**THREE OAKS RENEWABLE
ENERGY PARK
EXTENSION**

Highway Design Note

Highway Design Note

Table 4.1 East Riding Highway Authority Comments and Designer Responses

SCHEME TITLE Adoptable Highway Design
General Arrangement
Sheet 1

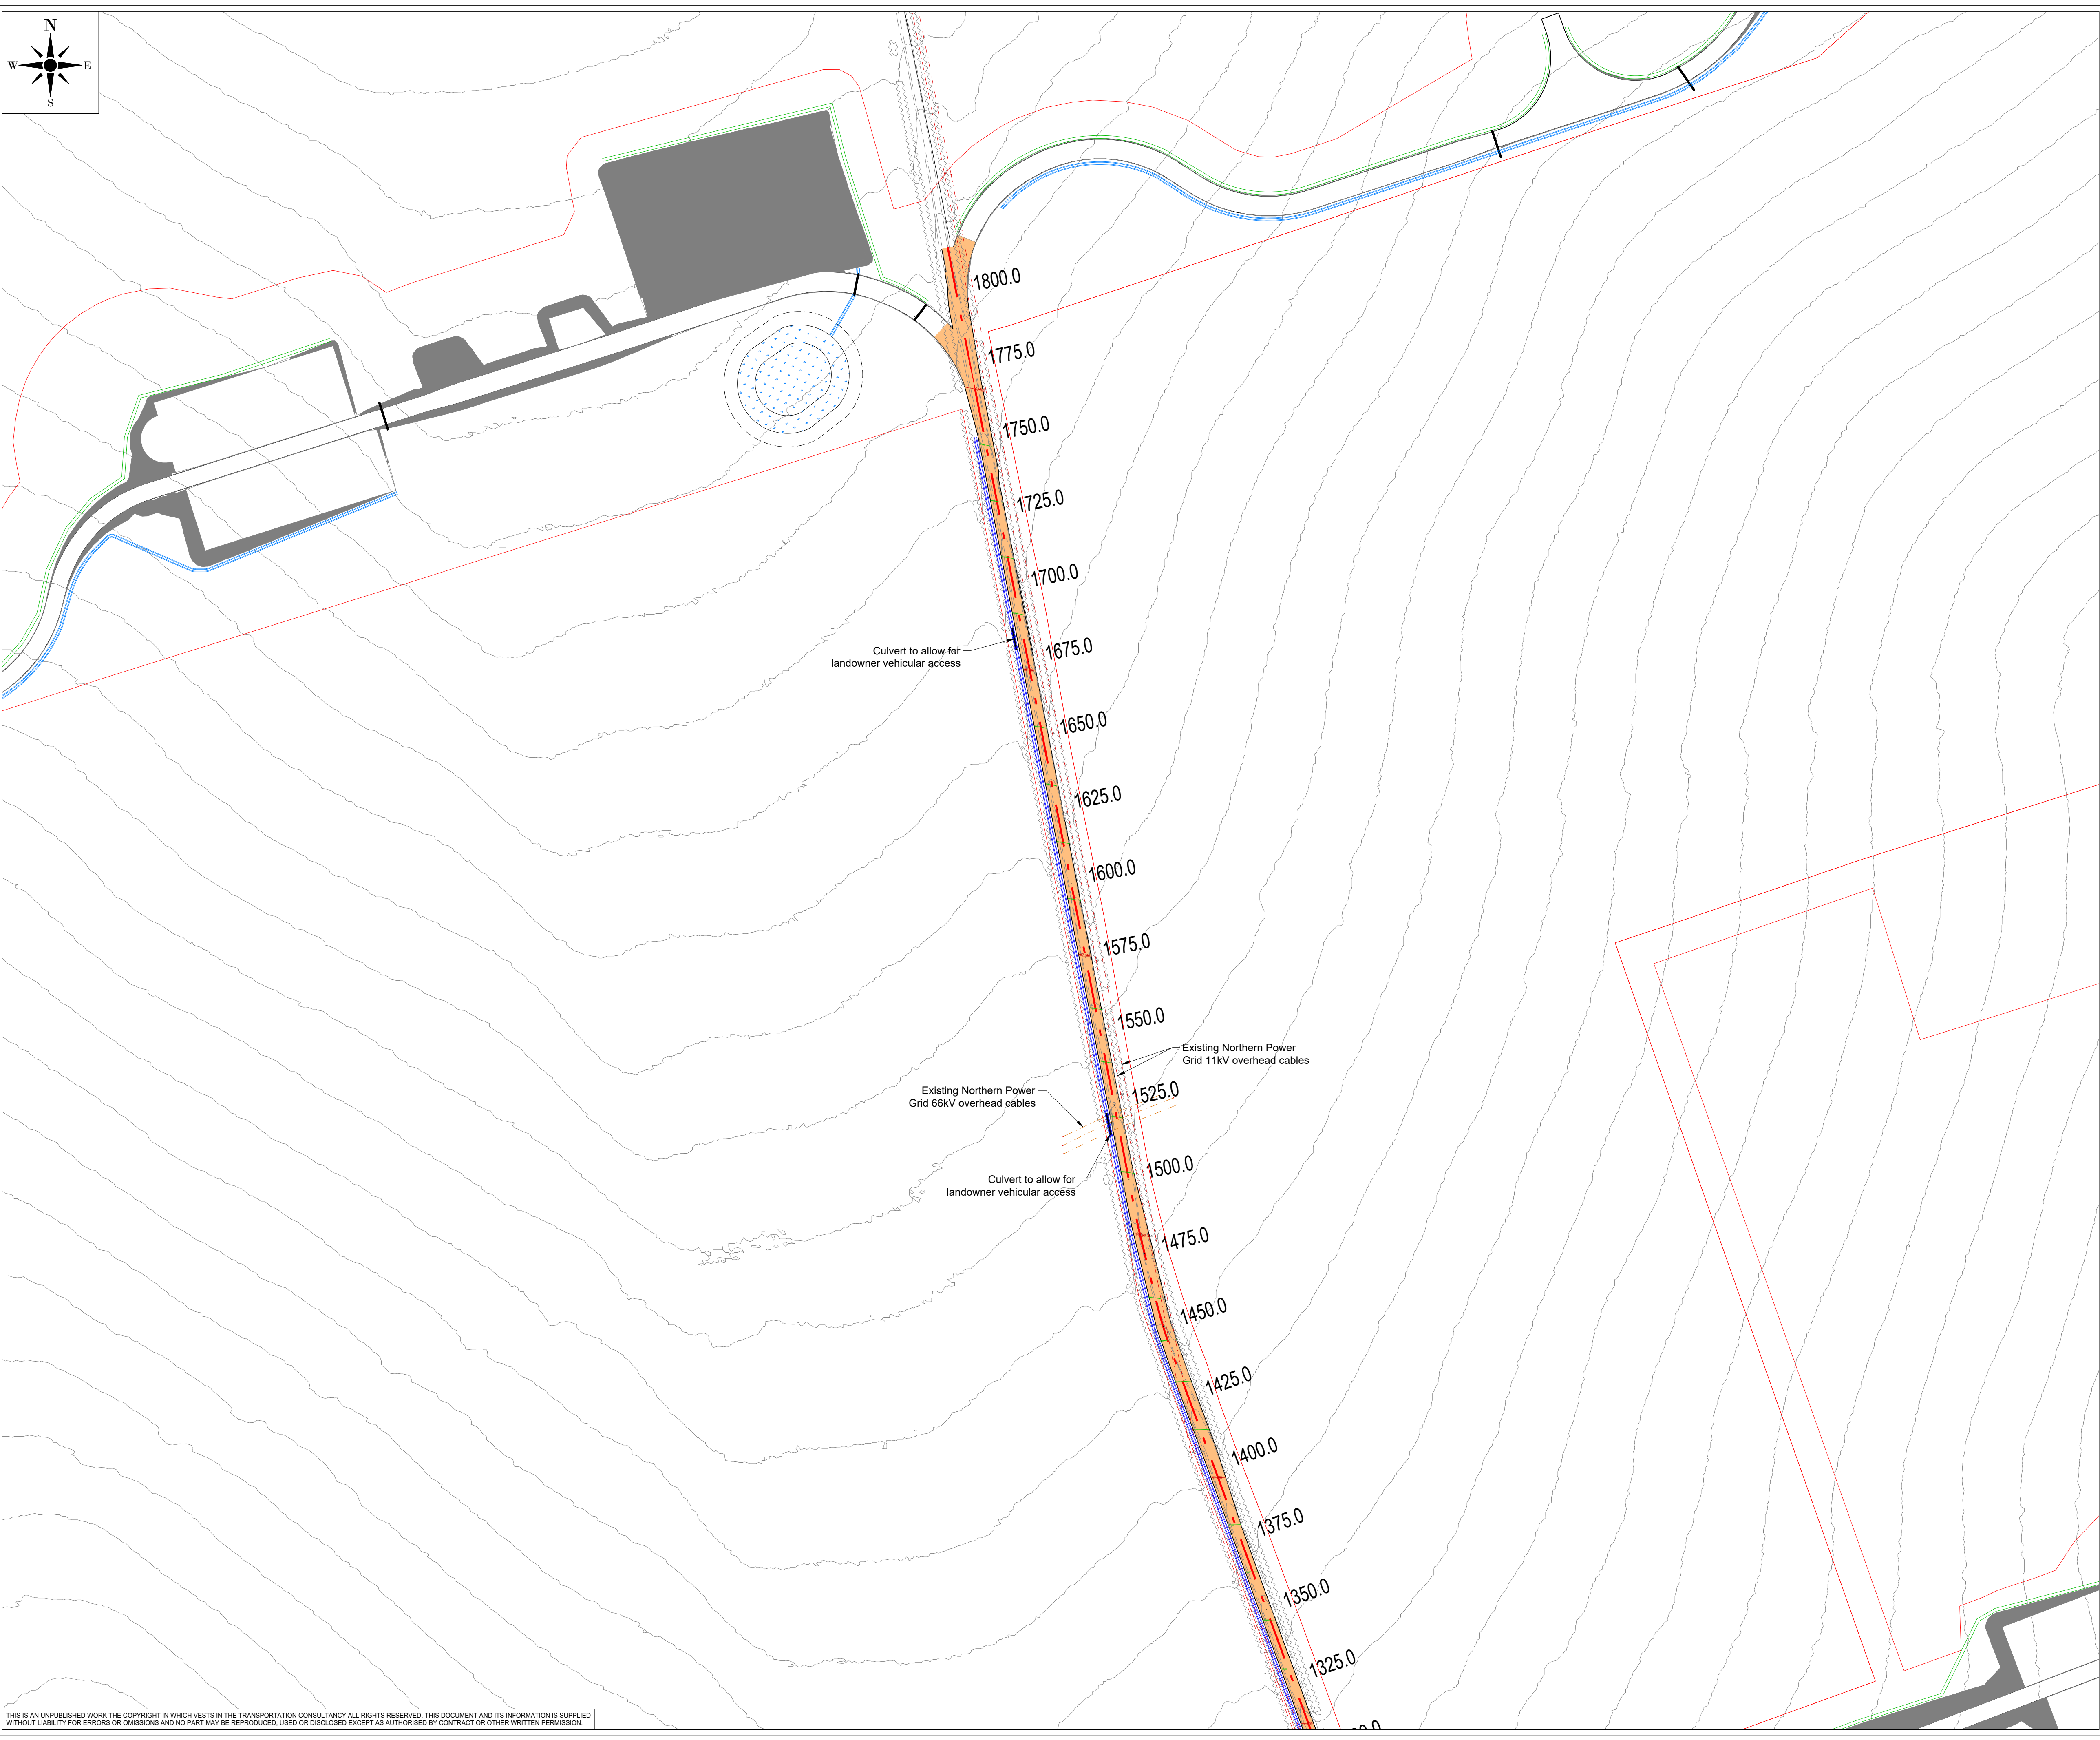
Reference	East Riding Highway Authority Comment	Response to Comment	Evidence References
1	Constraints at junction of the unmetalled highway and the A614 including accommodation of the proposed abnormal loads.	The junction is to be upgraded to a flexible road construction and will tie into the existing carriageway of the A614.	Abnormal Load Assessment, report reference 211213-04 Drawings 211213-04 Sheet 1 to 8
2	Two way passing movements for HGV should be demonstrated at any point under 7m of weight bearing carriageway because the impact of gradient and secure surface on laden HGV is a known constraint to safe access.	Two-way passing has been demonstrated to be achievable, with the use of passing bays.	Drawings 211213-04 Sheet 1 to 8
3	Constraints along the length of the unmetalled highway (gradient/unknown construction and it is likely that the weight bearing surface may be limited to 3m or less and impacted by water erosion).	The gradient of the existing road ranges from 1:20 (5%) to 1:100 (1%), which is within adoptable standards for an unrestricted speed limit (60mph) for a rural road. The existing road surface is unmetalled and is in a state of disrepair due to rutting from farm vehicle wheel tracks. The proposed pavement design assumes a CBR value of 3%, and an alternative design has been prepared for a CBR value of 2% to understand the differences.	Drawings 211213-TTC-XX-XX-CD-H-0003 211213-TTC-XX-XX-CD-H-0004 211213-TTC-XX-XX-CD-H-0005 211213-TTC-XX-XX-CD-H-0006 211213-TTC-XX-XX-CD-H-0007 211213-TTC-XX-XX-CD-H-0008 211213-TTC-XX-XX-CD-H-0009 211213-TTC-XX-XX-CD-H-0010
